NUREG-1047 Supplement No. 1

Saffety Evaluation Report related to the operation of Nine Mile Point Nuclear Station, Unit No. 2

Docket No. 50-410

June 1985

Figure 13.1 Safety review and audit of operations organization Source: FSAR Figure 13.4-1

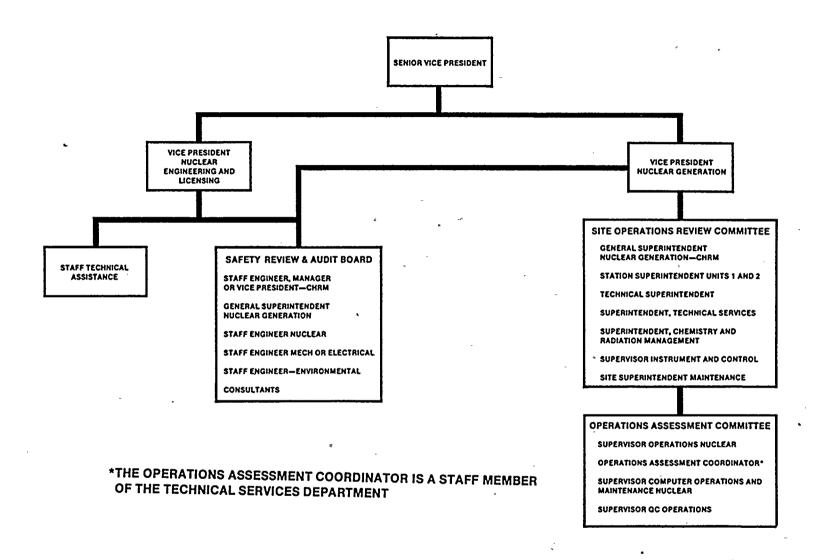
In the SER, the staff noted that the applicant had provided a detailed commitment to meet all of the requirements of TMI Action Plan Item I.C.5, but the information provided did not describe how outside information is obtained and who obtains it, how it is screened to ensure that it is sent to the people who

need it, and how it is ensured that appropriate action has been taken by those to whom it has been sent. In FSAR Amendment 15, the applicant provided more detailed information about the process.

Operating experience assessment is performed by the Technical Support Group, the Operations Assessment Committee (OAC), and the Site Operations Review Committee (SORC). The Supervisor of the Technical Support Group is, as a member of OAC, the Operations Assessment Coordinator, and the OAC meets regularly with the SORC. An OAC designee is also a member of the Independent Safety Engineering Group. This organizational arrangement ensures appropriate coordination among these groups. The relationship between SORC and OAC is shown in Figure 13.1.

On the basis of the additional information provided in FSAR Amendment 15, the staff concludes that the applicant's organizational arrangements will provide acceptable means for assuring that operating experience information will be provided to those who need it. This satisfies the requirements of TMI Action Plan Item I.C.5.
